WOG RISK-INFORMED ATWS MODEL

August 23, 2000

Westinghouse Owners Group Response to NRC Risk Informed ATWS Issues

Reactivity Balance at EOL for High and Low
Reactivity Cores for T_{in} of 580 °F

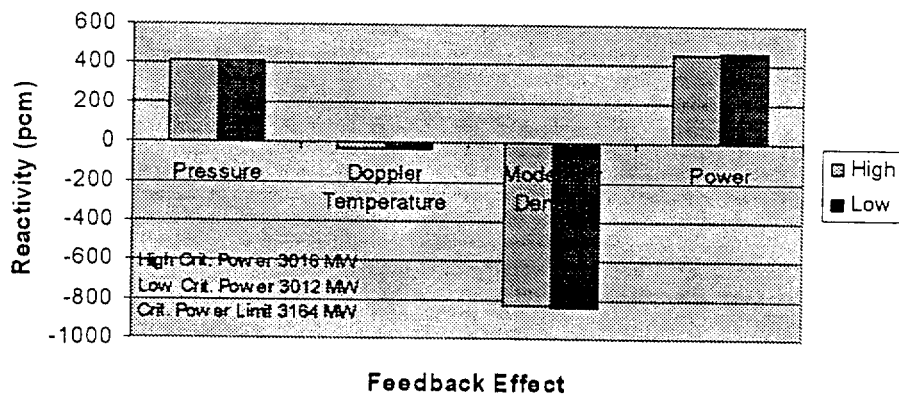
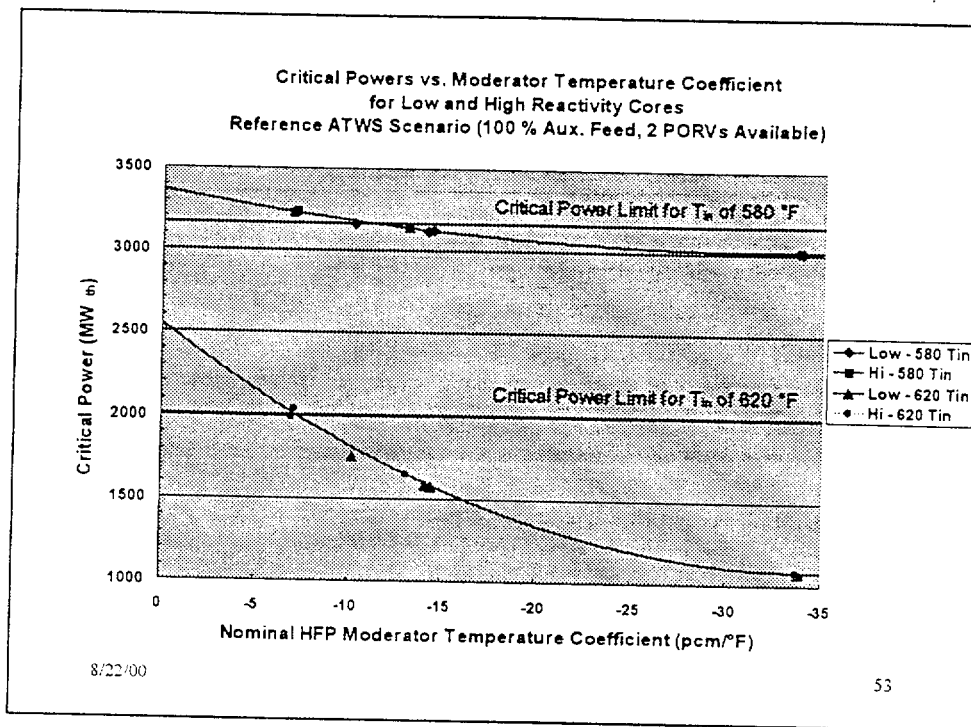
NRC/WOG Meeting
WOG Risk-Informed ATWS Model
Issue 6: UET/MTC Link

- UET approach implicitly includes a reactivity balance of all feedback effects through the critical power search.
- Cores with comparable reactivity feedbacks have comparable critical powers and similar performance for a given ATWS scenario.
- The reactivity feedback required to protect 3200 psig is a function of the ATWS scenario (plant configuration, T_{in}).
- Low and high reactivity cores achieve the required reactivity feedbacks at different times in life leading to different UETs.

Figure 1
Critical Powers vs. Moderator Temperature Coefficient
for Low and High Reactivity Cores
Reference ATWS Scenario (100 % Aux. Feed, 2 PORVs Available)

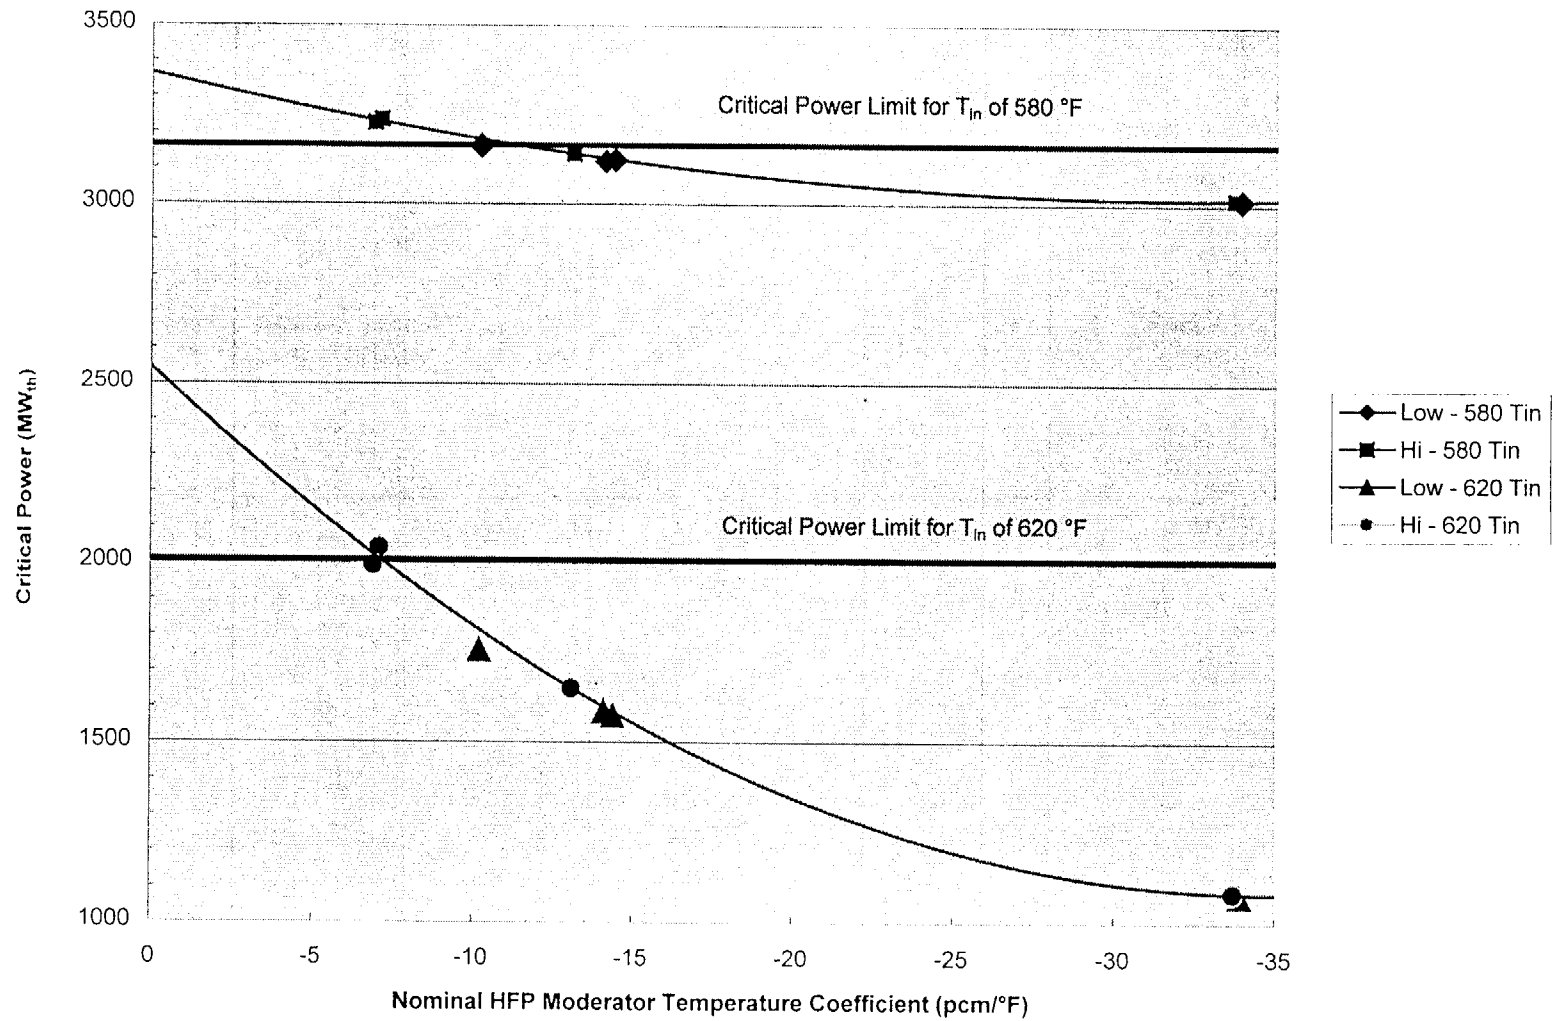
Response**Unfavorable Exposure Time and Critical Power Trajectories**

Figure 1 illustrates how the critical power varies with HFP MTC. Figure 1 plots the calculated critical powers for the low and high reactivity cores as a function of HFP MTC for both the 580 °F and 620 °F inlet temperature cases. The plotted values come from Tables 1 and 2. Note that both cores follow the same critical power versus MTC trendlines. This means that for a given inlet temperature and HFP MTC, both cores would be expected to have similar critical powers.

In the risk-informed approach being proposed, all of the reactivity effects discussed above (Doppler, moderator, and power feedbacks) are implicitly included in the evaluation of each ATWS scenario through the reactivity balance that is inherent in the critical power and UET calculations. In this way, the particular feedback characteristics of a specific core design and the critical power limits appropriate for a particular plant are accounted for in the overall risk evaluation.
